Triax A/S

TDX/TDH800 Release

4.4.1.39167

Release description of TDX and TDH800 software release

3.1 IP out at AUX:

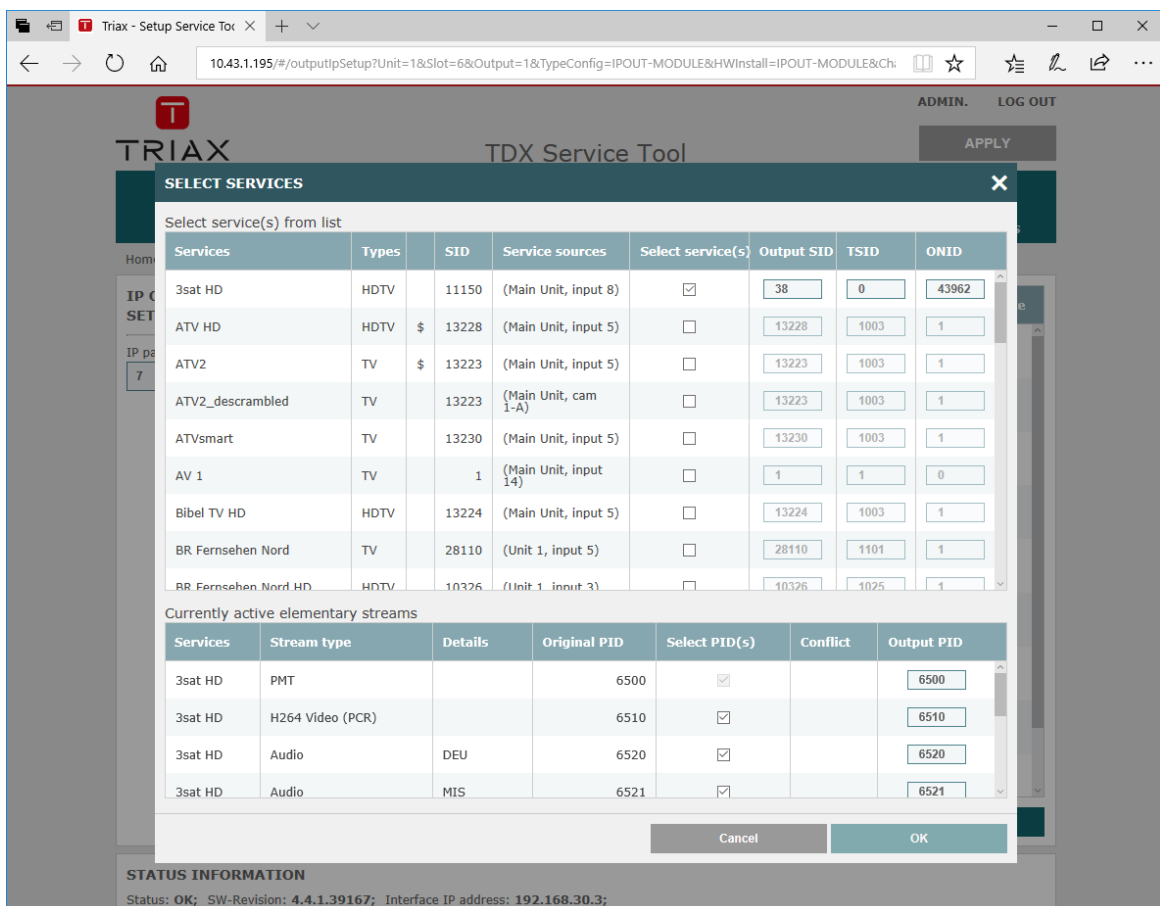
It is now possible to set the ONID and TSID at IP-out at AUX (from IP BE). Before was the values fixed for ONID and TSID. ONID was 0xABBA (43962) and TSID was 0x00 (0).

The default values for the ONID, TSID and SID is now the origin from the input. Already configured IP-outs will keep the values given at the configuration time, so making a SW update to this version will not change the ONID and TSID but keep the old setting.
